ADDENDUM #1

SPANGS Building P-1 Interior Repair - BGS Project # 3700

South Portland Air National Guard Station, 50 Western Ave, South Portland, ME 04601

28 August 2023

AE001

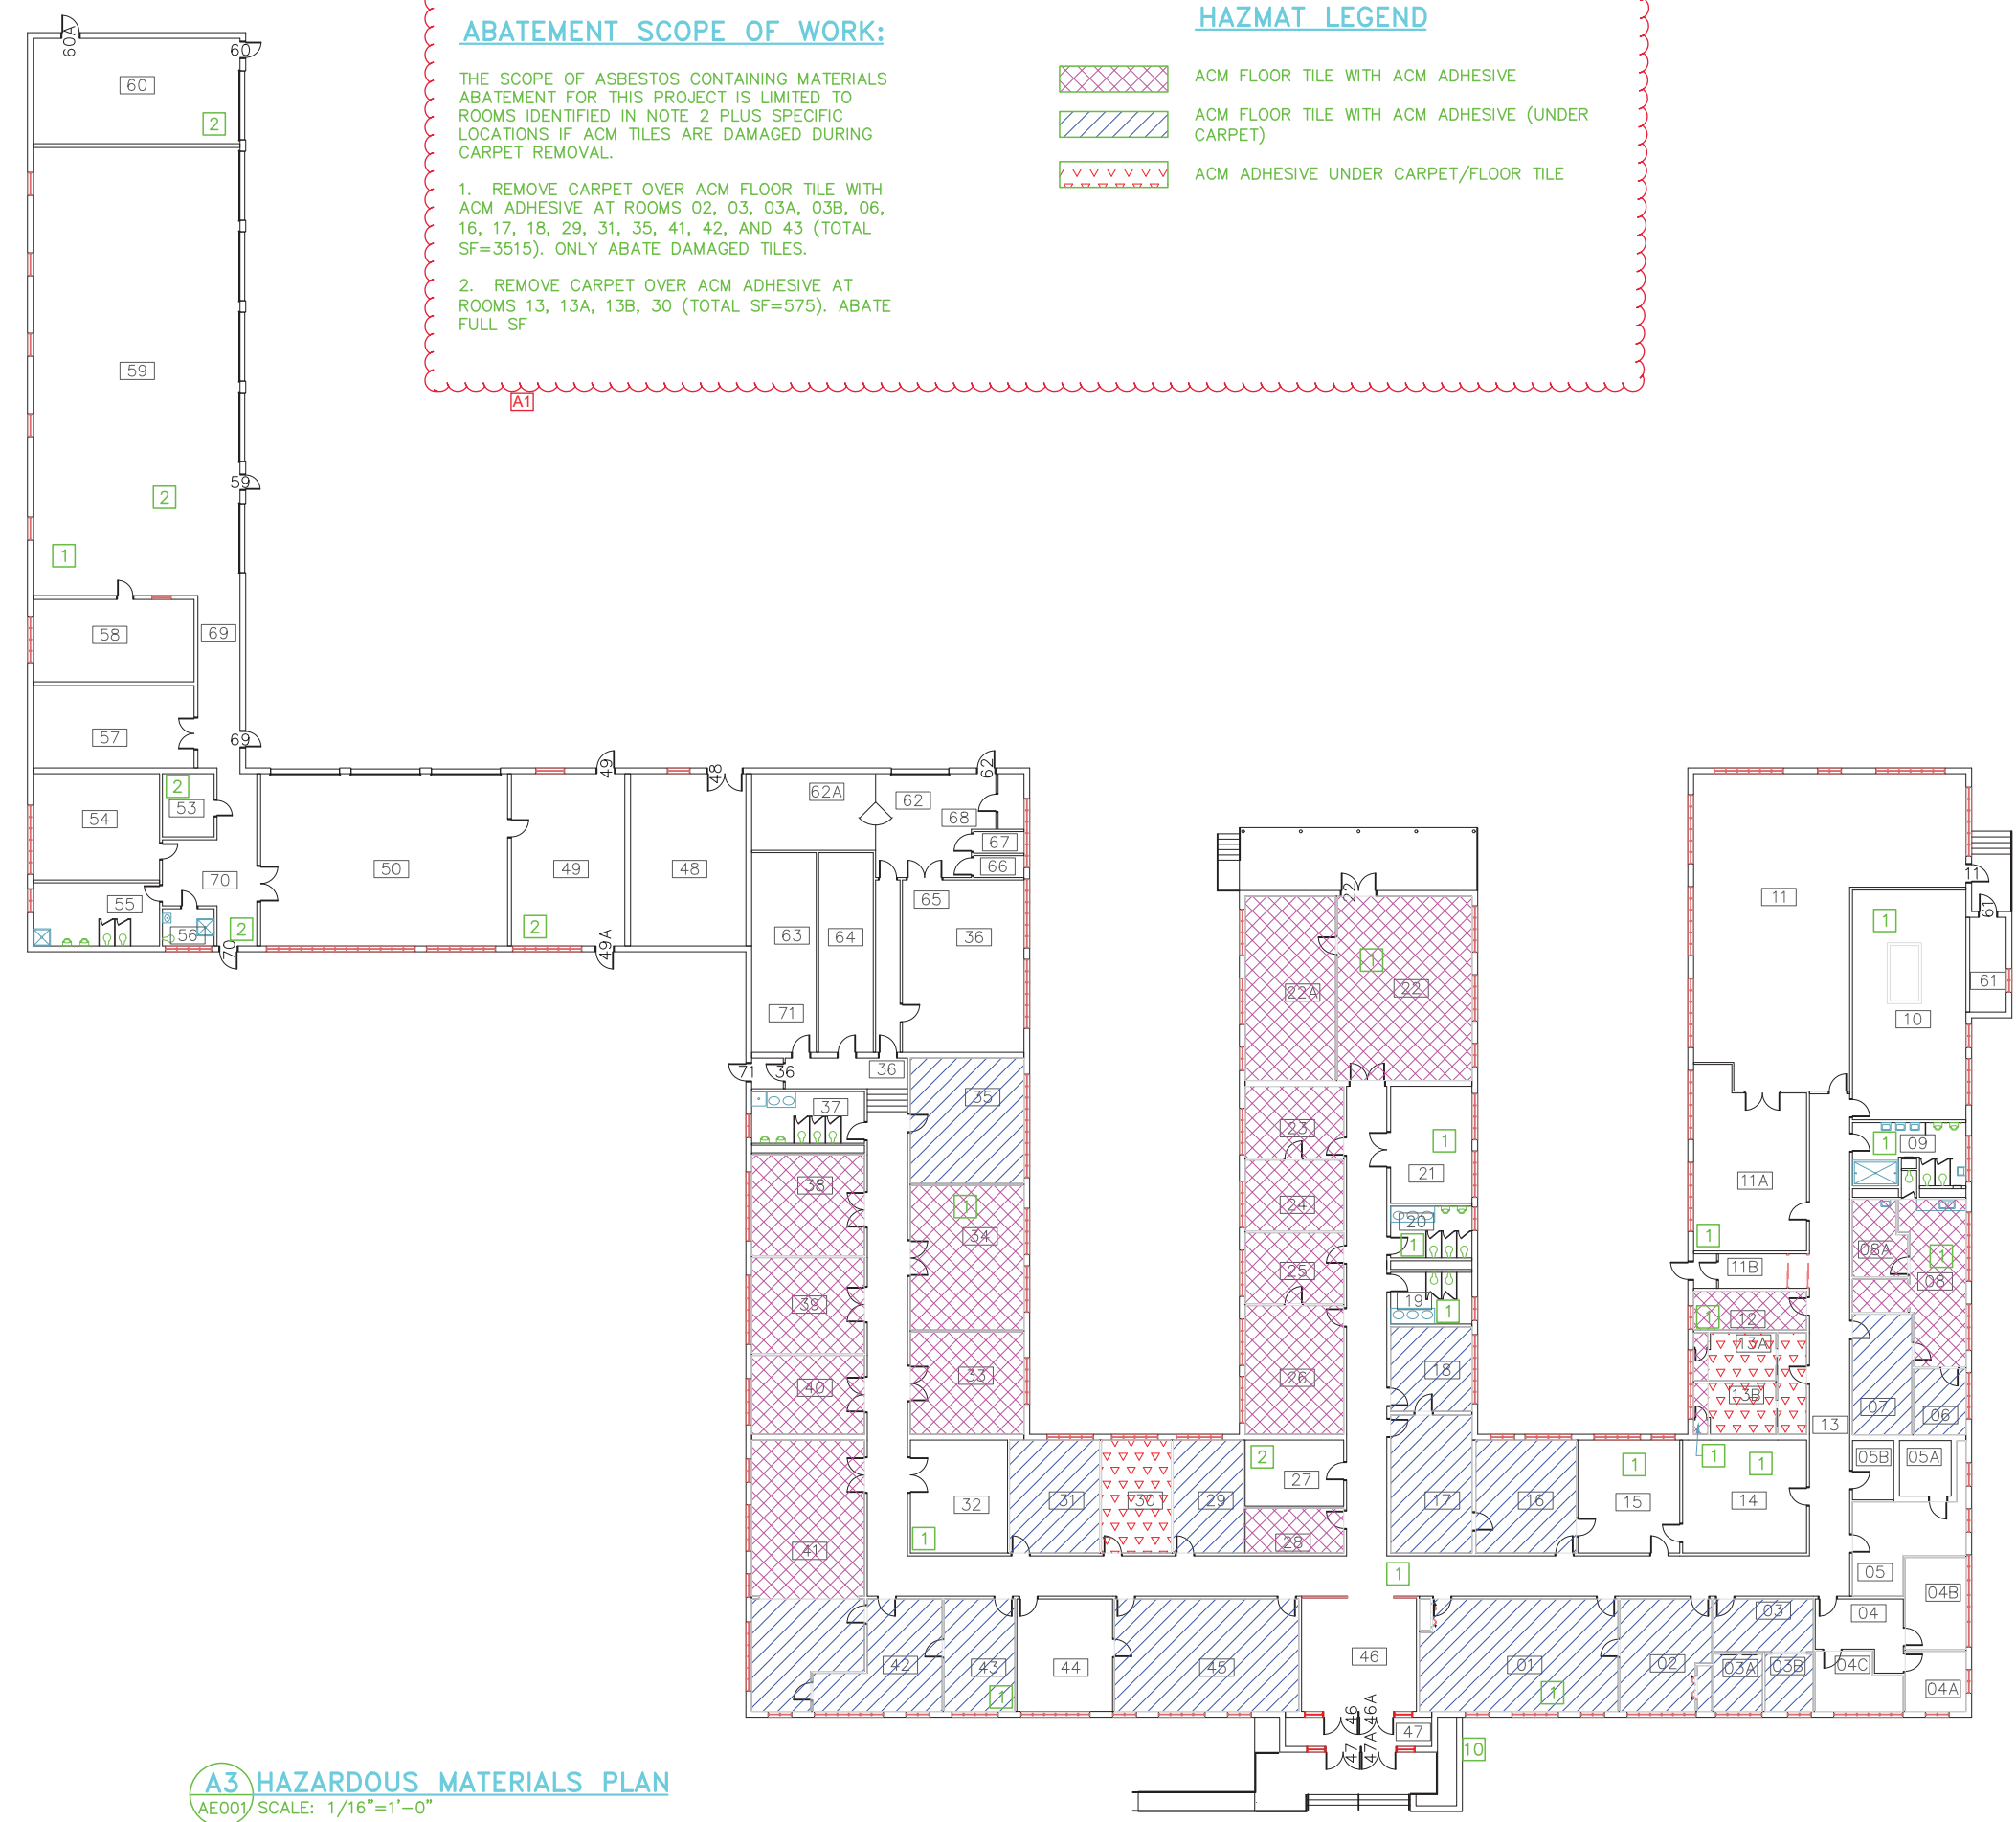
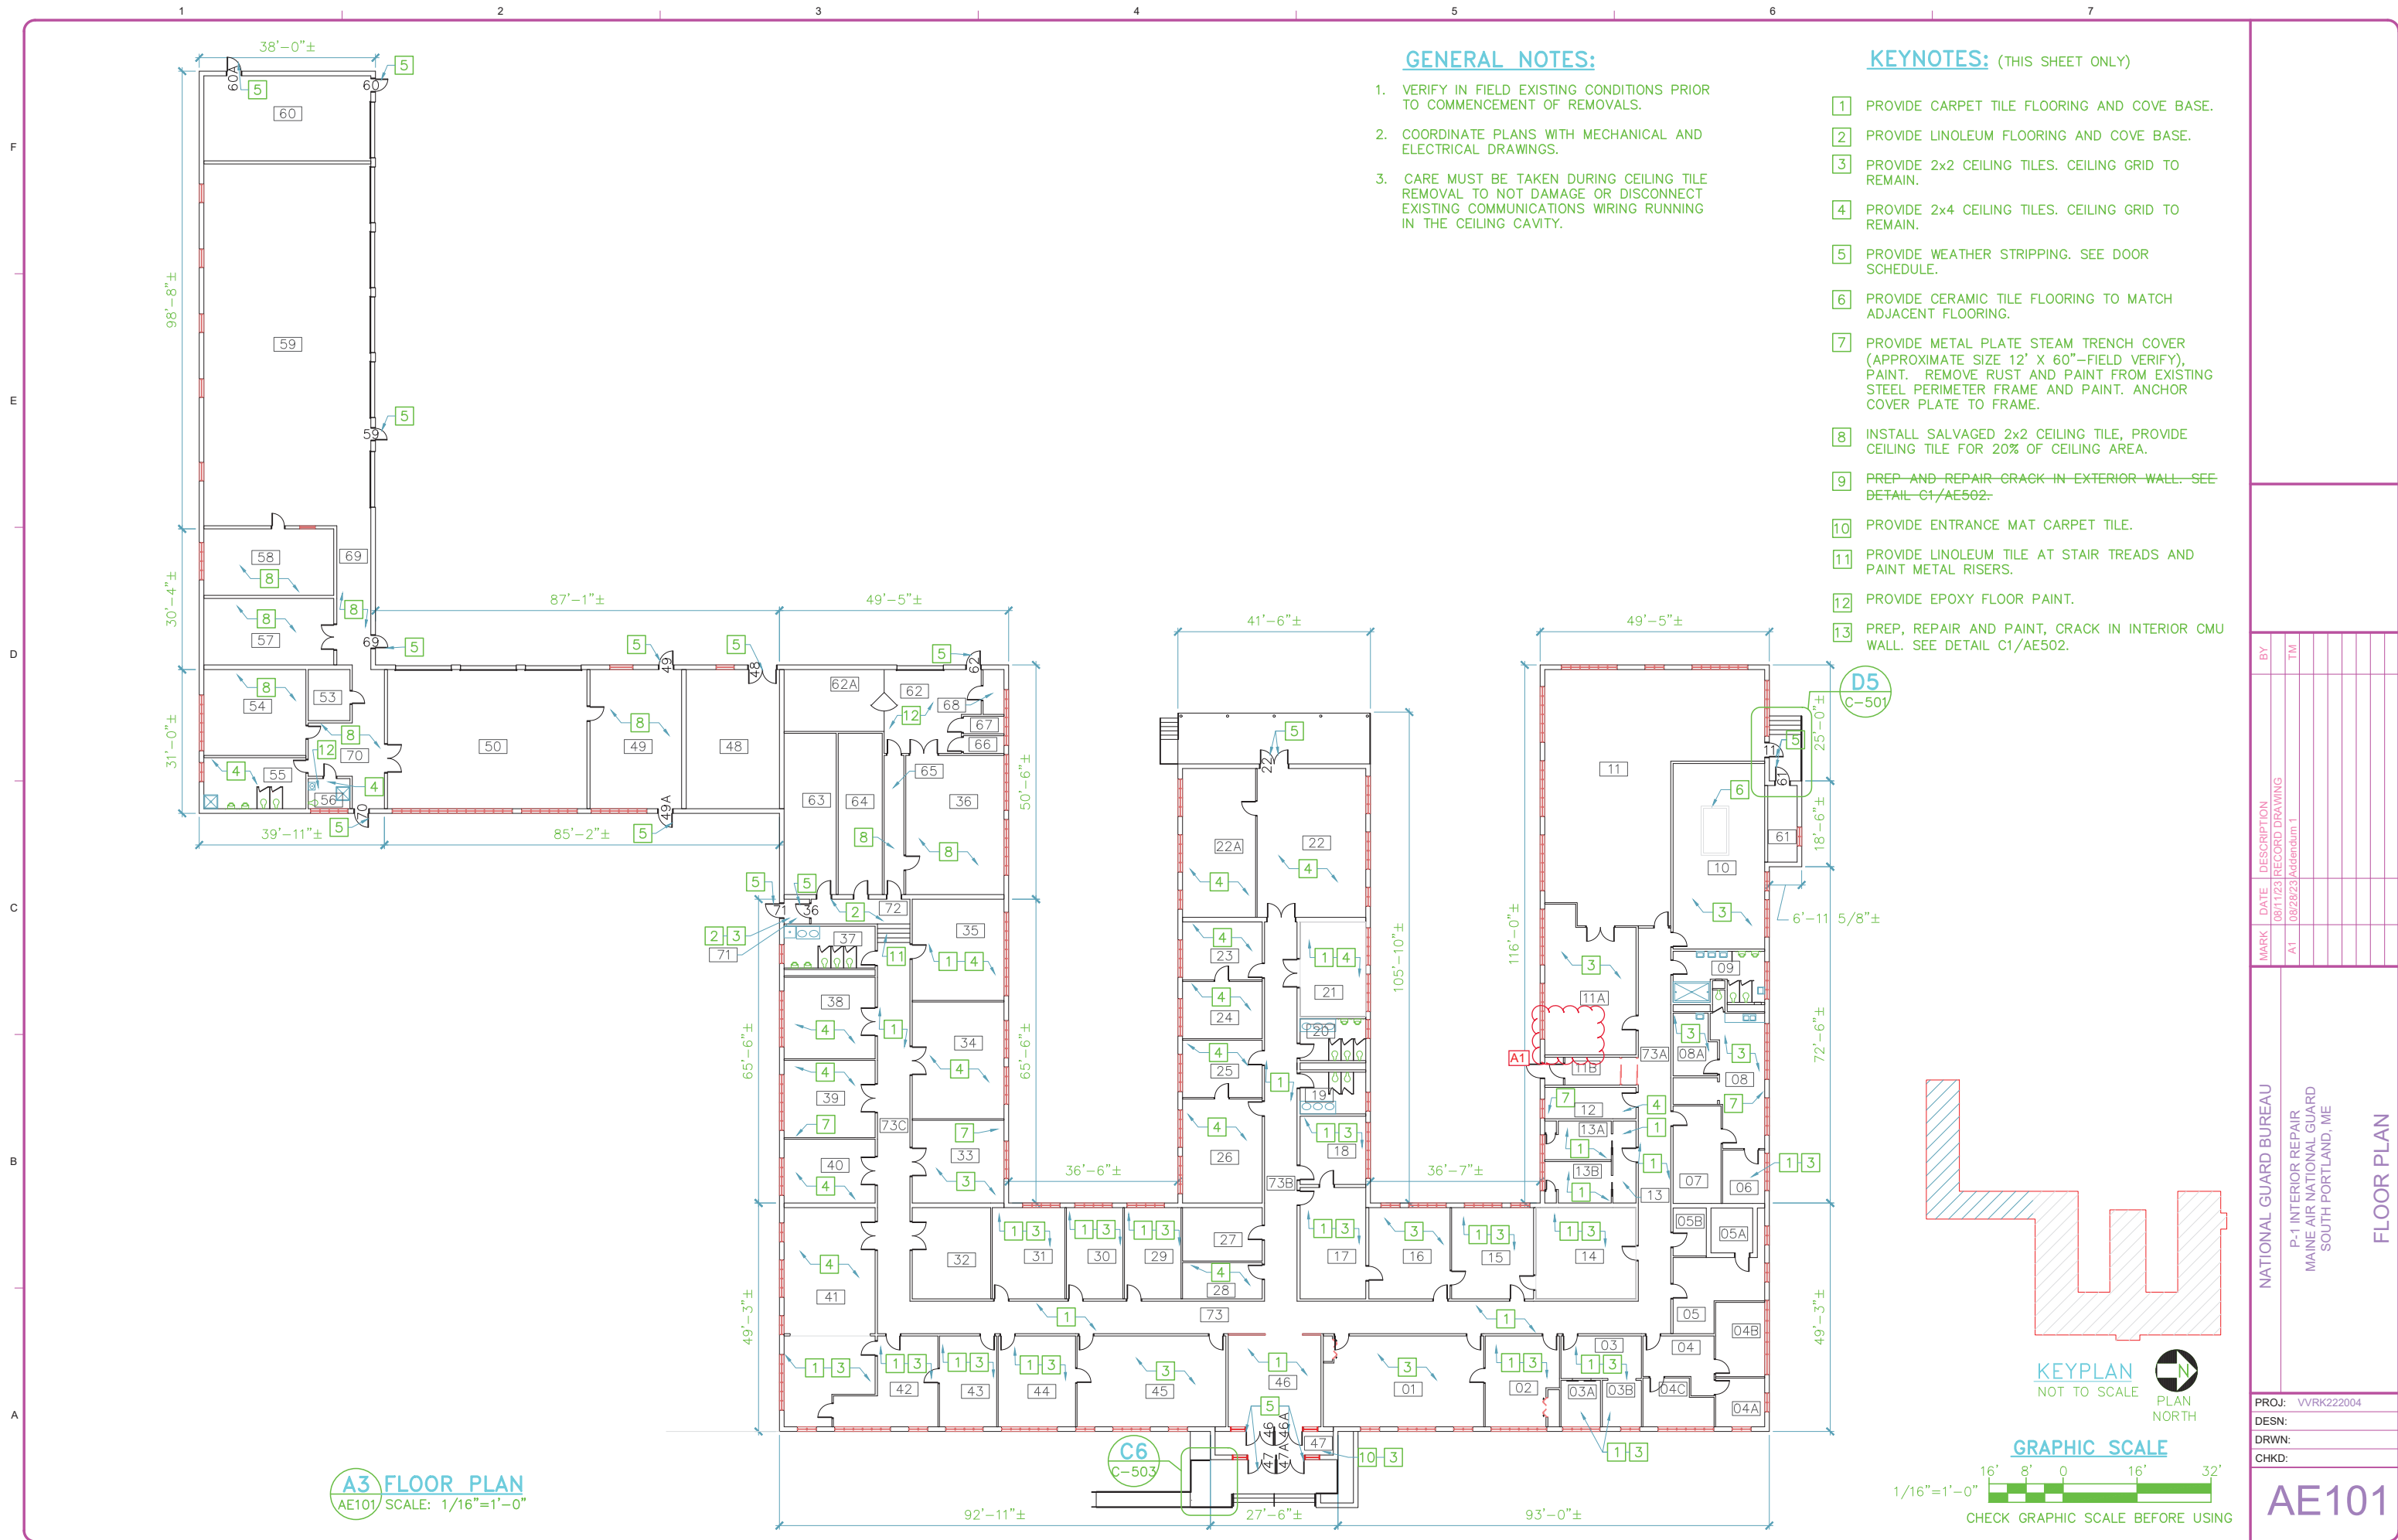
1. Is there an allowance for the ACM abatement work?
 - a. No. See 01 10 00 and Drawings G002 and AE001 for the ACM Abatement included in the base bid.
 - i. Drawings G002 - UNIT PRICE AND QUANTITY SCHEDULE - ITEM 1 has been updated.
 - ii. Drawing AE001-
 1. ABATEMENT SCOPE OF WORK has been modified.
 2. The color and pattern of the hatching has been modified for clarity.
 - iii. Section 01 10 00 - Summary of Work, Paragraph 3.1.2 has been modified to include the Asbestos Abatement Base Bid SF amount.

ABATEMENT SCOPE OF WORK:

THE SCOPE OF ASBESTOS CONTAINING MATERIALS ABATEMENT FOR THIS PROJECT IS LIMITED TO ROOMS IDENTIFIED IN NOTE 2 PLUS SPECIFIC LOCATIONS IF ACM TILES ARE DAMAGED DURING CARPET REMOVAL.

1. REMOVE CARPET OVER ACM FLOOR TILE WITH ACM ADHESIVE AT ROOMS 02, 03, 03A, 03B, 06, 16, 17, 18, 29, 31, 35, 41, 42, AND 43 (TOTAL SF=3515). ONLY ABATE DAMAGED TILES.

2. REMOVE CARPET OVER ACM ADHESIVE AT ROOMS 13, 13A, 13B, 30 (TOTAL SF=575). ABATE FULL SF
